Job Sheet 164202

Part Name: Fwd Crosstube - High 407

DART AEROSPACE LTD HAWKESBURY, ONTARIO, CANADA	
DRAWING NO. D407-667-145	REV. C SHEET 1 OF 4
TITLE CROSSTUBE ASS'Y (407 HIGH FWD)	SCALE NTS
COPYRIGHT © 2002 BY DART AEROSPACE LTD THIS DOCUMENT IS PROPRIETARY AND CONFIDENTIAL AND IS SUPPLIED ON THE EXPRESS CONDITION THAT IT IS NOT TO BE USED FOR ANY PURPOSE OR COPIED OR COMMUNICATED TO ANY OTHER PERSON WITHOUT WRITTEN PERMISSION FROM DART AEROSPACE LTD.

DRAWING NO. D407-667-145	TITLE CROSSTUBE ASS'Y (407 HIGH FWD)	REV. C	DART AEROSPACE LTD ENGINEERING ORDER		D.E.O. NO. D407-667-145-C-1	SHEET NO. SHEET 1 OF 1	SCALE NTS
DRAWN <i>Q</i>	CHECKED <i>ASS</i>	MFG. APPR. <i>IS</i>	APPROVED <i>WD</i>		DE APPR. <i>#</i>		
DATE 11.07.15	DATE 11.07.22	DATE 11.07.22	DATE 11/07/22		DATE 11.07.21

DRAWING NO. D407-667-145	TITLE CROSSTUBE ASS'Y (407 HIGH FWD)	REV. C	DART AEROSPACE LTD ENGINEERING ORDER	D.E.O. NO. D407-667-145-C-2	SHEET NO. SHEET 1 OF 1	SCALE NTS
DRAWN AJS	CHECKED	MFG. APPR.	APPROVED	DE APPR.		
DATE 12.08.02	DATE 12.08.02	DATE 12.08.02	DATE 12.08.02	DATE 12.08.02

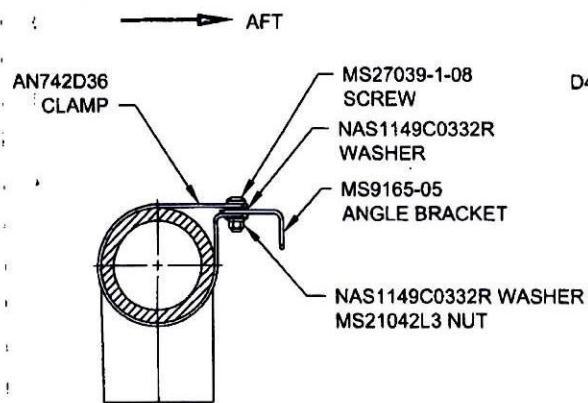
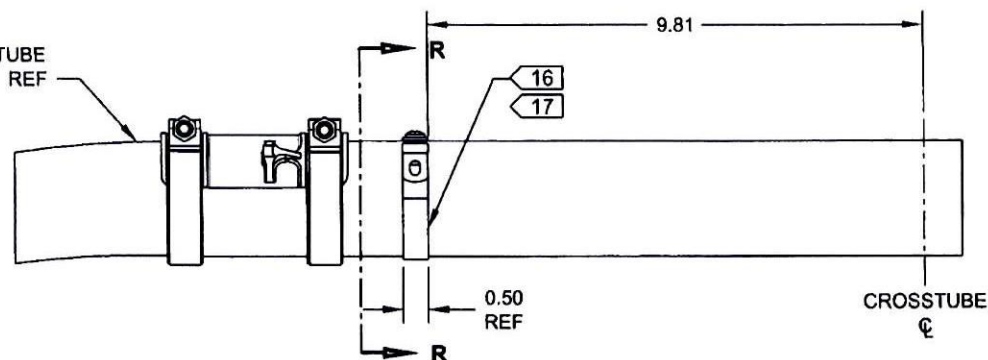
ADD ELECTRICAL GROUNDING STRAP

ITEM	QTY	PART NUMBER	DESCRIPTION
1	X	D407-667-145	CROSSTUBE ASSEMBLY (407 HIGH FWD)
10	2	AN742D36	CLAMP
11	2	MS9165-05	ANGLE BRACKET
12	2	MS21042L3	NUT (OR MS21042-3)
13	2	MS27039-1-08	SCREW
14	4	NAS1149C0332R	WASHER (OR AN960C10L)

DETAIL P
BONDING STRAP INSTALLATION 2 PL
